工程指示 / 要求簡箋(E.I.)

工程指示編號：EI / 5614 / 23

工程名稱：將軍澳日出康城 11

工程項目：偏林箱 拆圖和生產 (加雀網)

類別		物料號	
制圖	胡冬雲	2023.1.10	圖號 858-PL-BOX01
修改	-	-	數量 146+4(後備)=150
日期	-	-	位置
復核	-	-	
批准

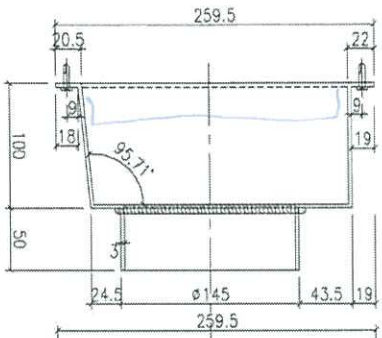
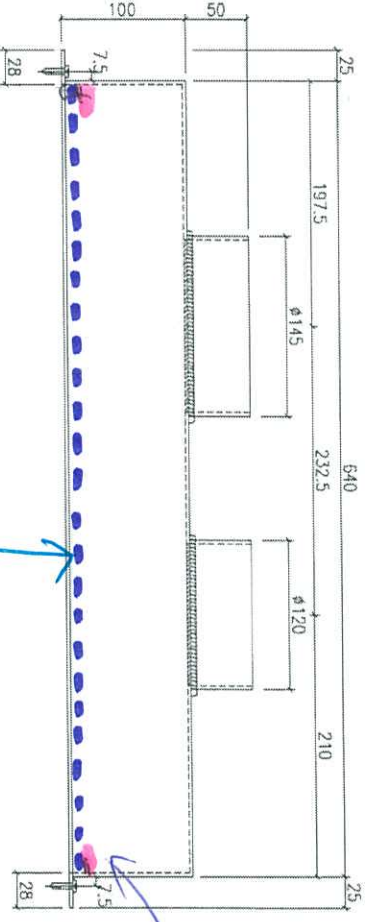
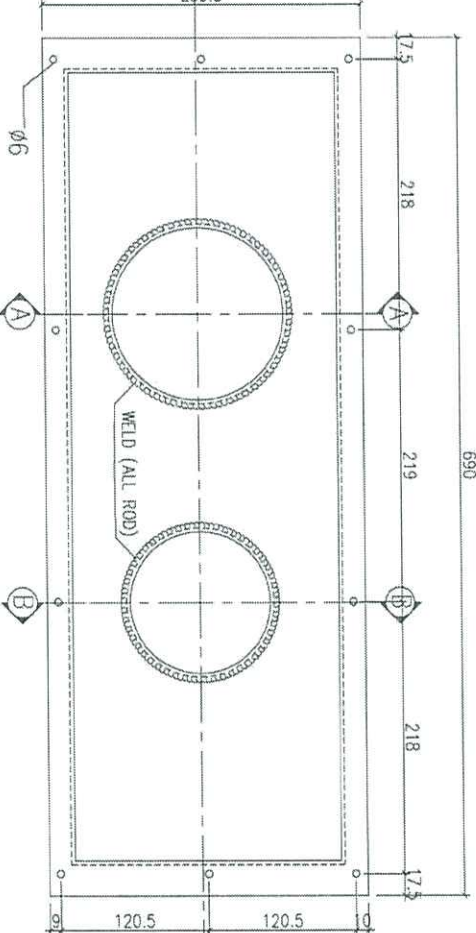
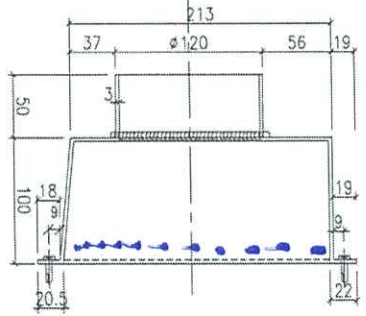
**A: 按顧問要求，需要加雀網。請按附件修改 拆圖  
請鈹金廠拆圖。**

**所有偏林箱，需要鉻化。3mm 厚**

先打

加多條

WELD (ALL ROD)

網眼 10x

線粗 2mm

加多條  
P.H.H  
145/16
